P&Z CASE # SP2021-012 P&Z DATE 05/11/21 CC DATE _____ APPROVED/DENIED _____

SP2021-012- AMENDED SITE PLAN FOR 259 RANCH TRAIL
SITE PLAN - LOCATION MAP =

PROJECT NUMBER: SP2021-012
PROJECT NAME: Amended Site Plan for 259 Ranch Trail
SITE ADDRESS/LOCATIONS: 259 RANCH TRL, ROCKWALL, 75032

TO: Planning and Zoning Commission
DATE: May 11, 2021
APPLICANT: Mike Prince; *Truman Heights LLC*
CASE NUMBER: SP2021-012; *Amended Site Plan for 259 Ranch Trail*

SHEET **SL1**

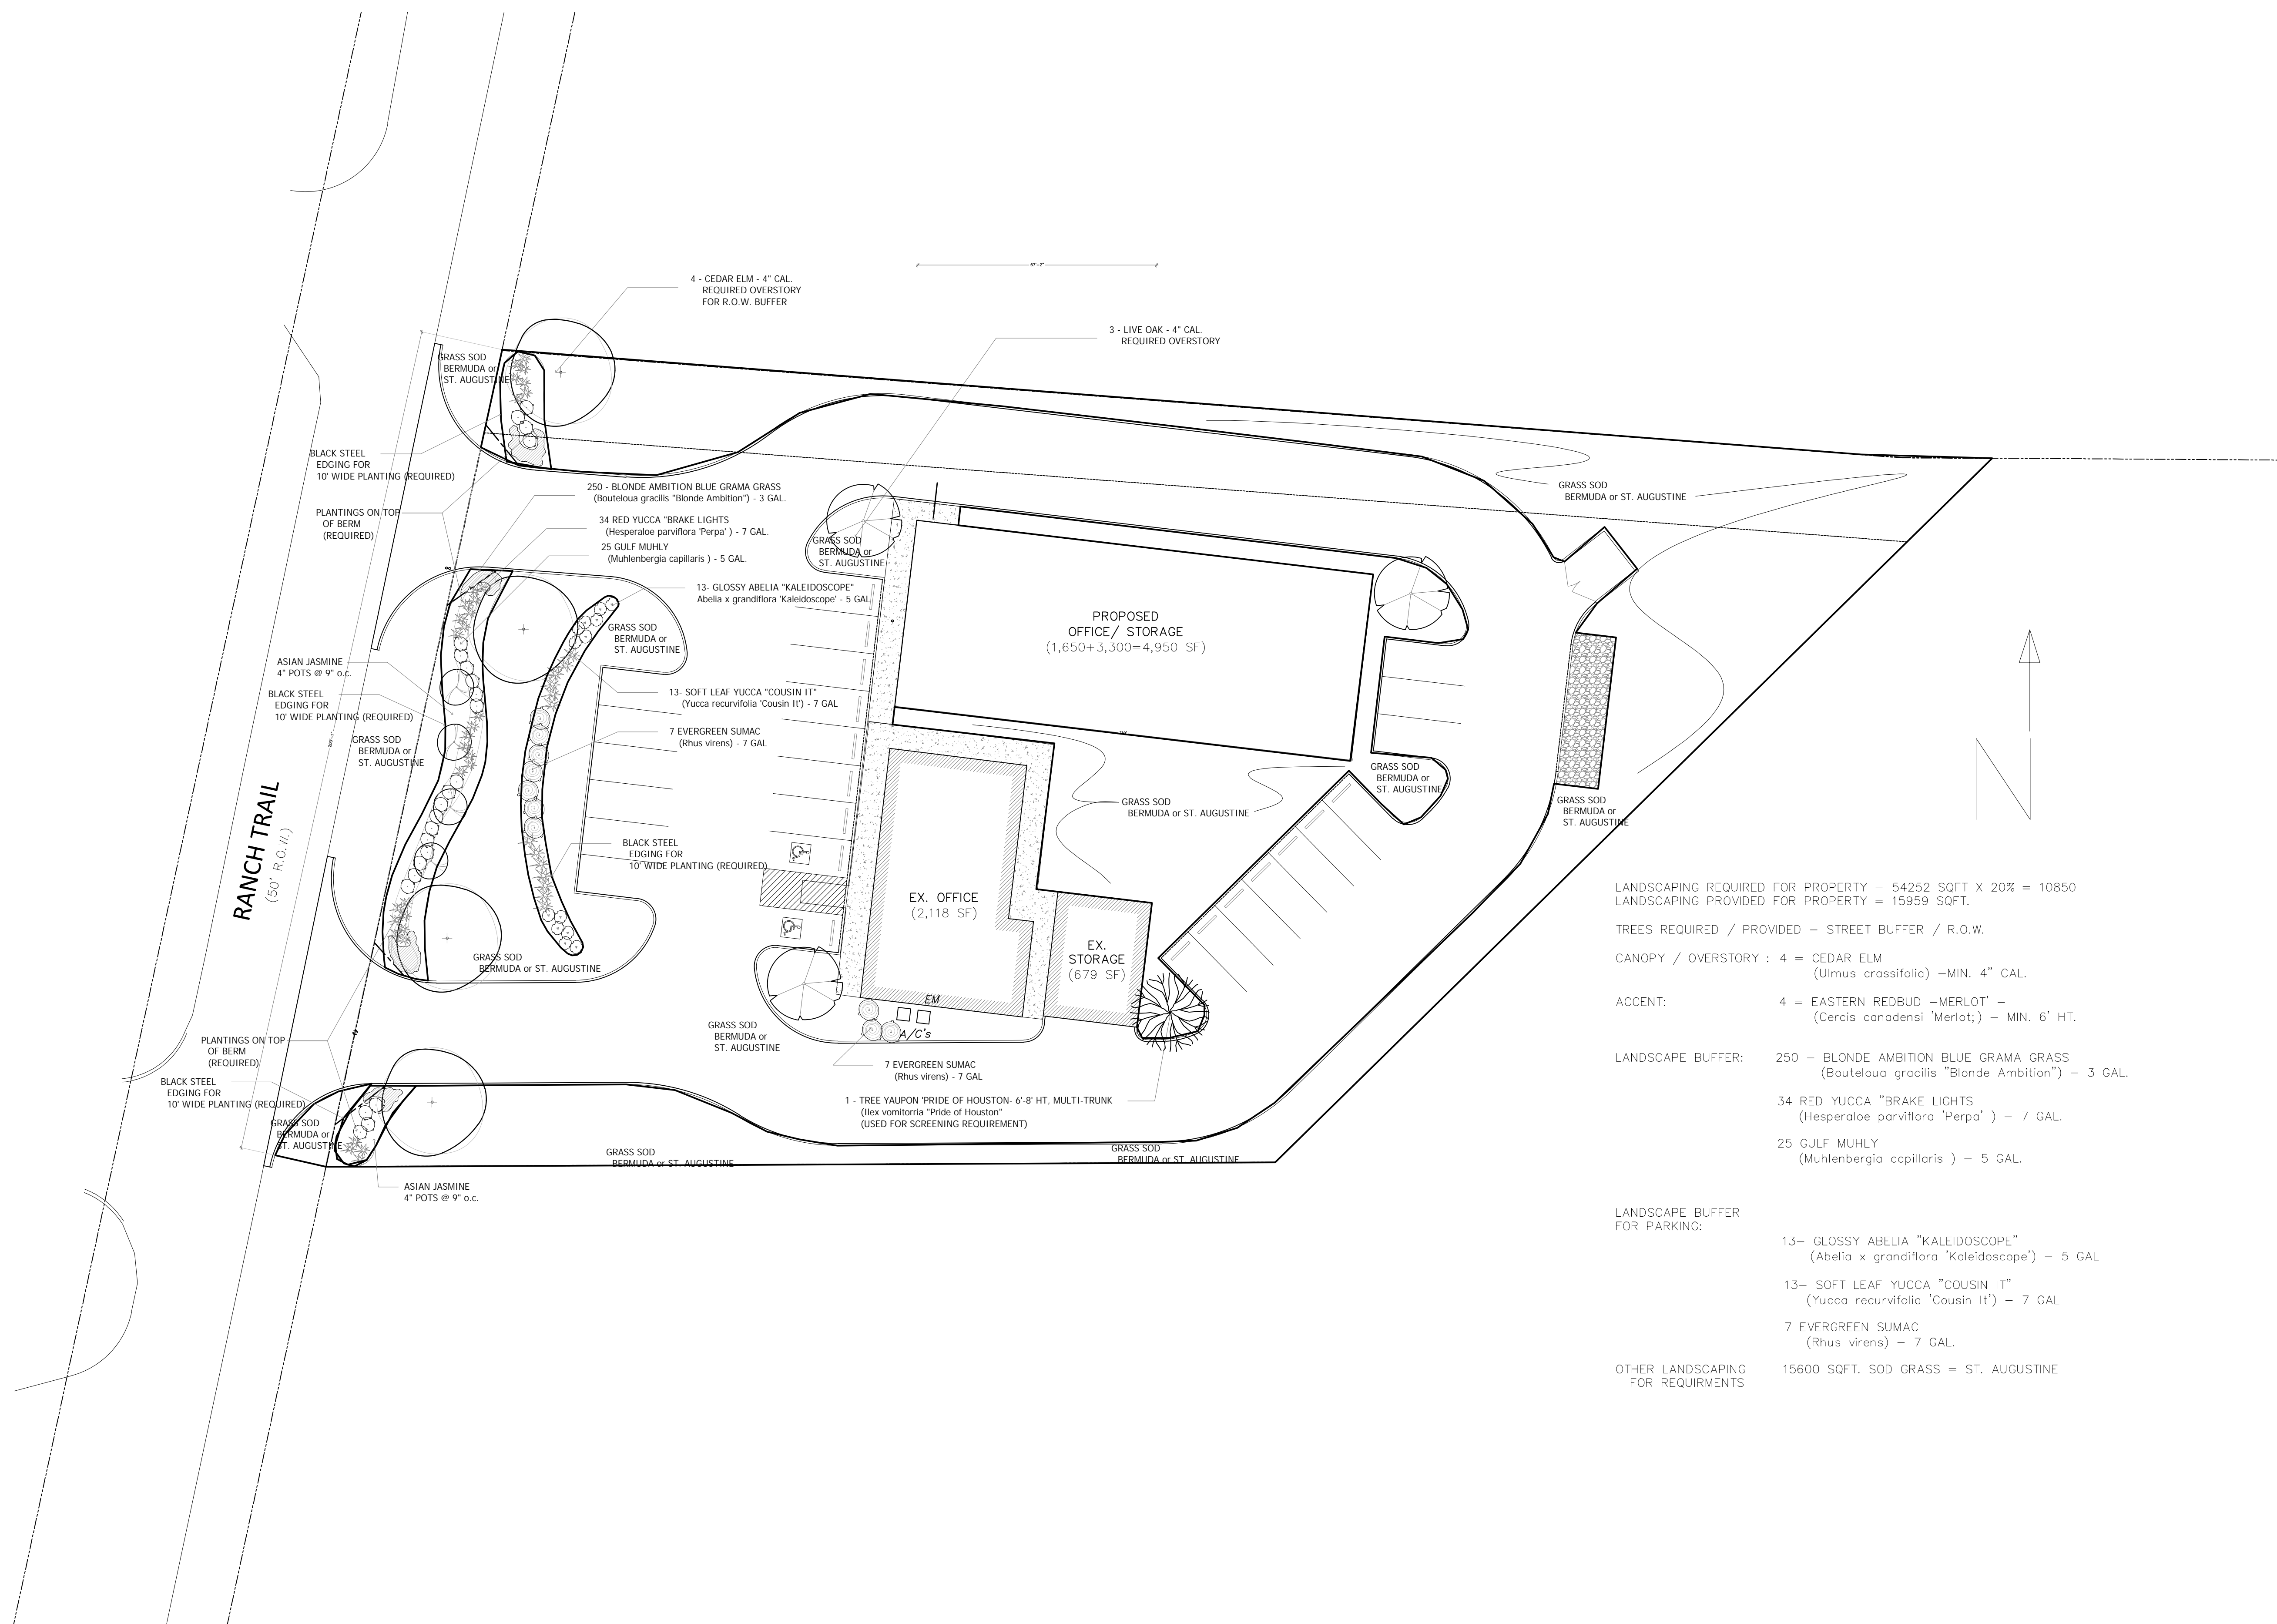
M.7 Photometric Plan:

1. Provide the same site data information required in Section 2.1 Site Plan: Miscellaneous and Density and Dimensional Requirements of this checklist. (Section 2.1 of this checklist)
2. Adjust your lighting to meet the following: The maximum outdoor maintained, computed and measured illumination level within any nonresidential development shall not exceed 20 FC outdoors at any point on the site, with a maximum of 0.2 FC at the property line. Currently both of these standards are not meet given the proposed photometric plan (Subsection 03.03. G, of Article 07)
3. Verify and indicate the up lighting; no up lighting shall exceed 15W. (Subsection 03.03. A, of Article 07)
4. Provide cutsheets of all proposed lighting. (Subsection 03.03, of Article 07)

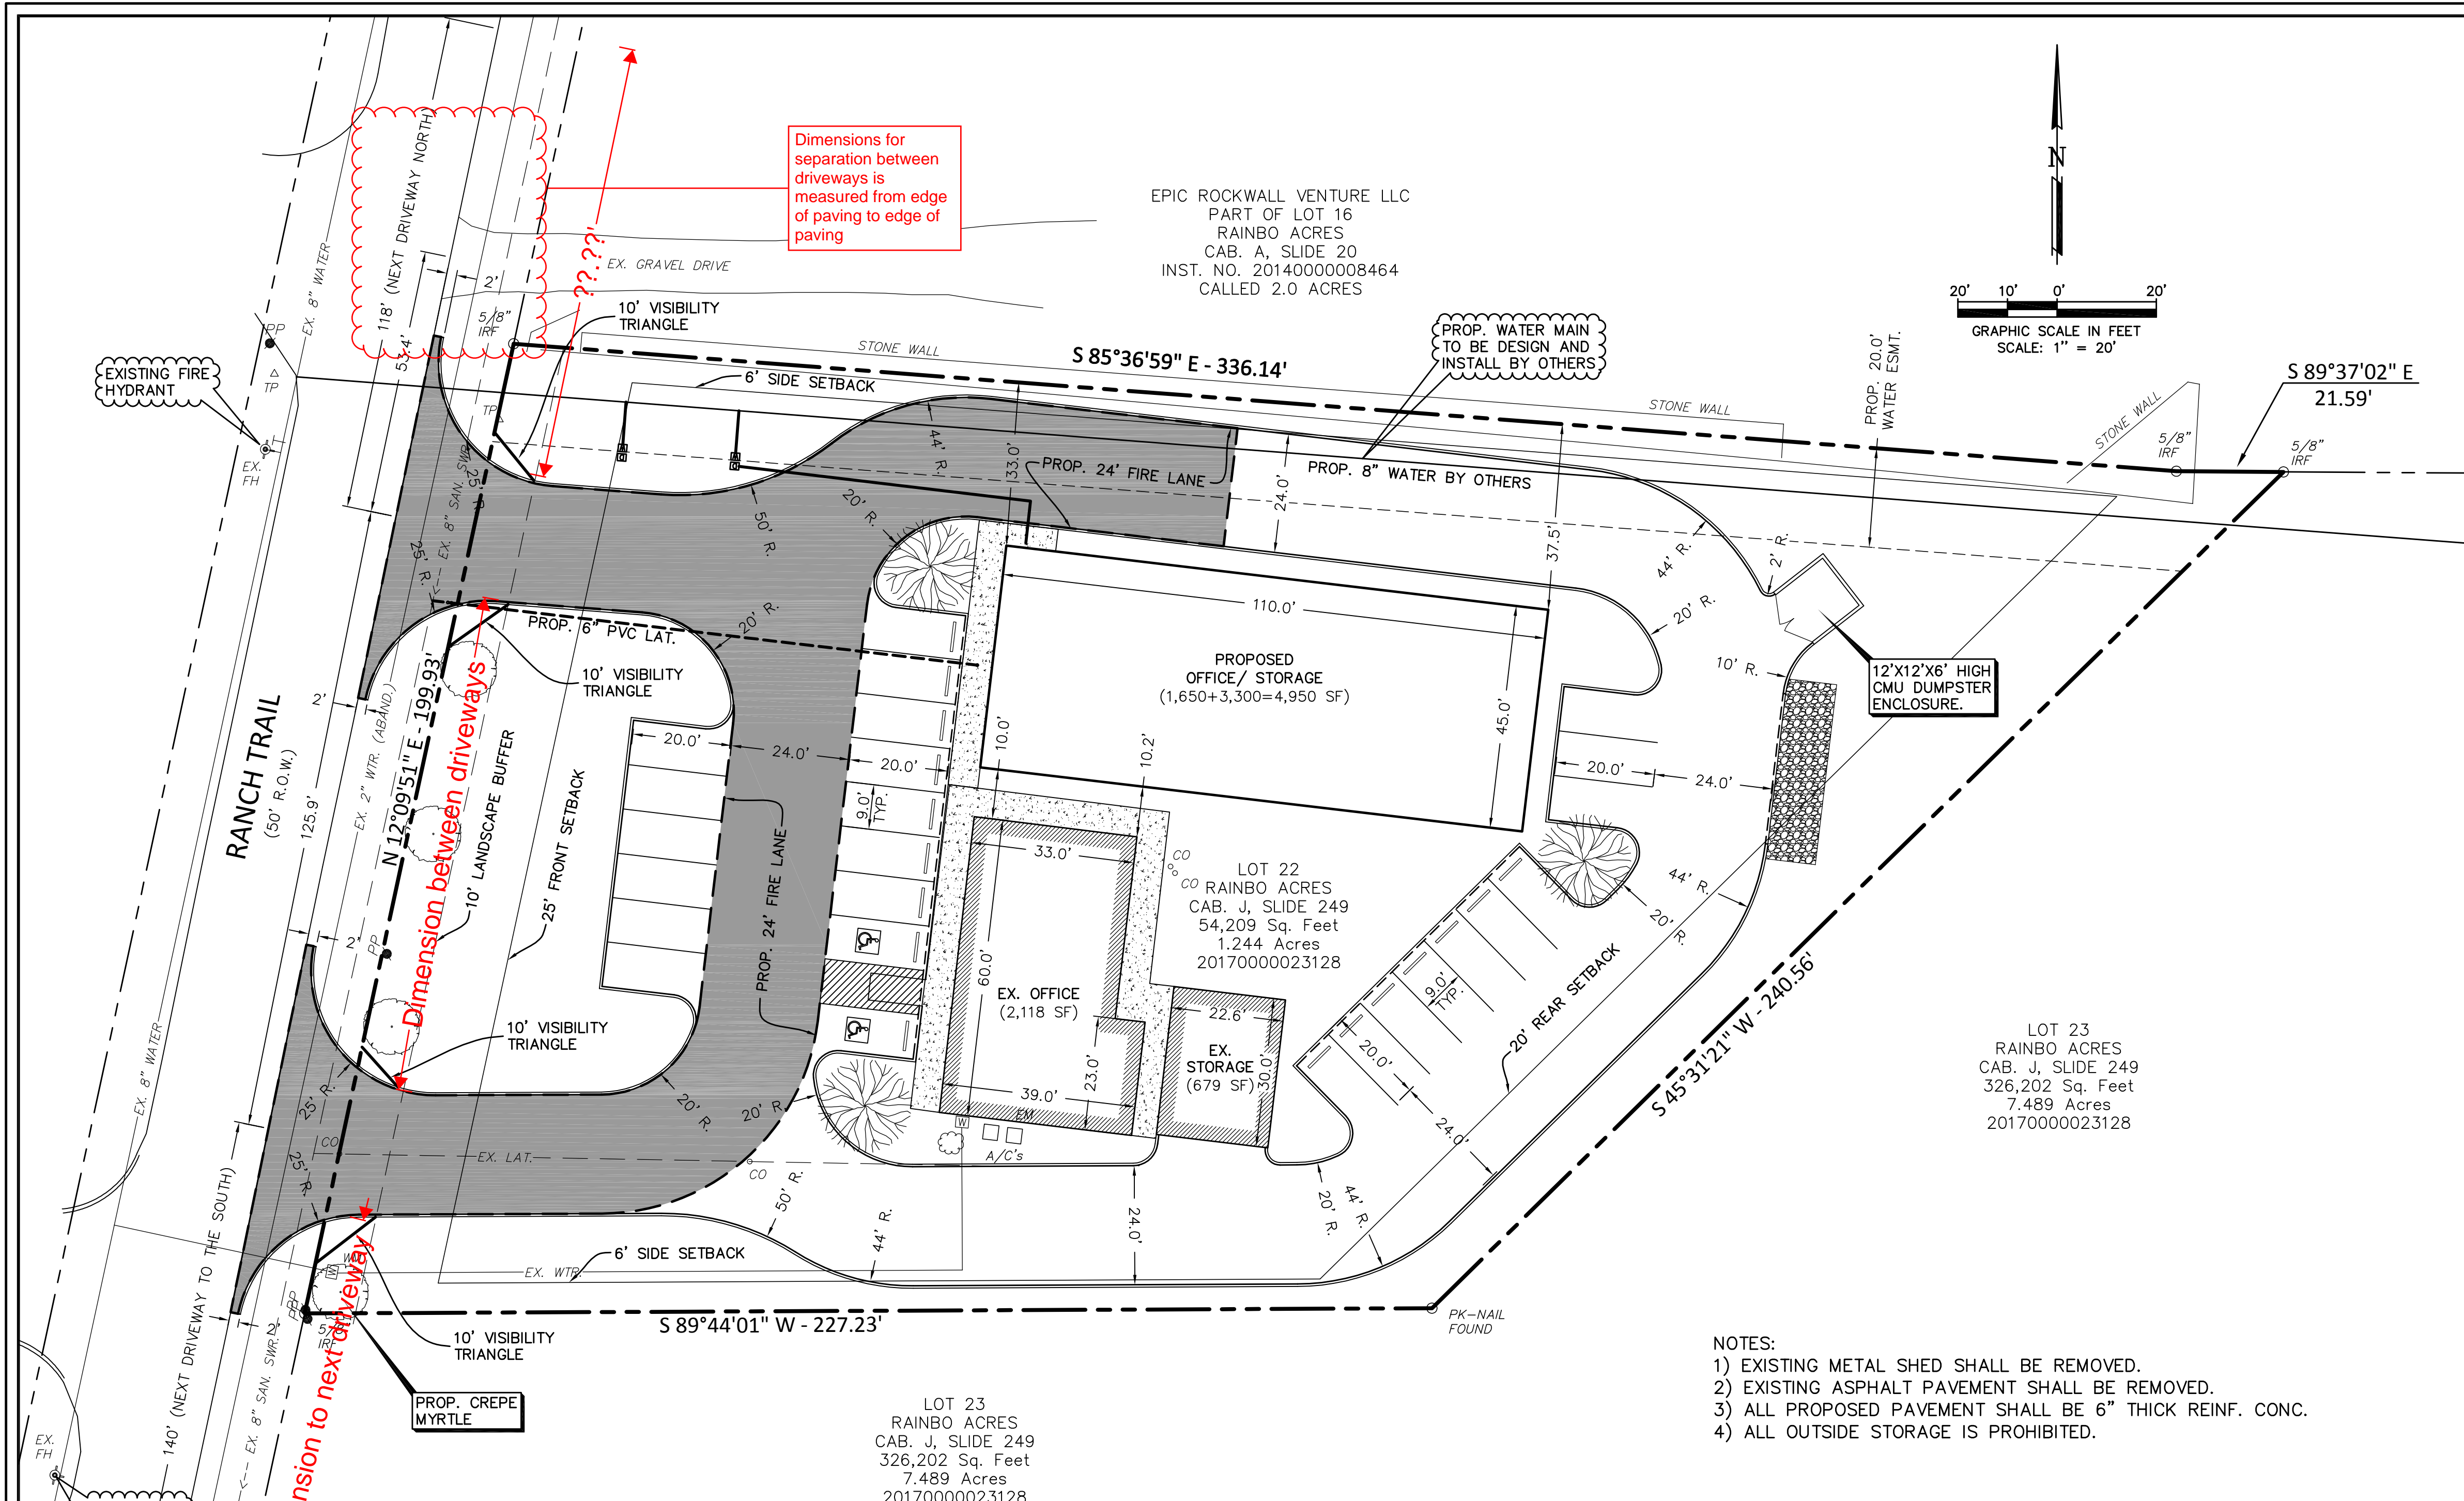
M.5 Site Plan:

1. The signature block is required on all sheets of the plans. (Subsection 03.04.A, of Article 11)
2. If the plans have been updated since 2019 the date created needs to be updated. (Subsection 03.04. A, of Article 11)

4. Label the fire lane easements as Fire Lane, Public Access, & Utility Easement. (Subsection 03.04. B, of Article 11)
5. The Ranch Trail right-of-way (ROW) is 60-feet and requires 30-feet of ROW on each side of the centerline. Correct the plans to reflect this; subsequently more ROW may need to be dedicated. Consult with the engineering department on this requirement. (Subsection 03.04. B, of Article 11)

8. Show all proposed and existing utility equipment (pad/ground and roof mounted) and their subsequent screening. Pad mounted must be screening from any public ROW and adjacent properties; the existing units are still visible from the southern property. Roof mounted must not be visible from the street or adjacent properties. (Subsection 01.05. C, of Article 05)

M.10 There are currently three (3) variances with the proposed plans, which are as follows: horizontal articulation, vertical articulation, and roof pitch. The letter requesting the variances will need to be updated to include the vertical articulation.
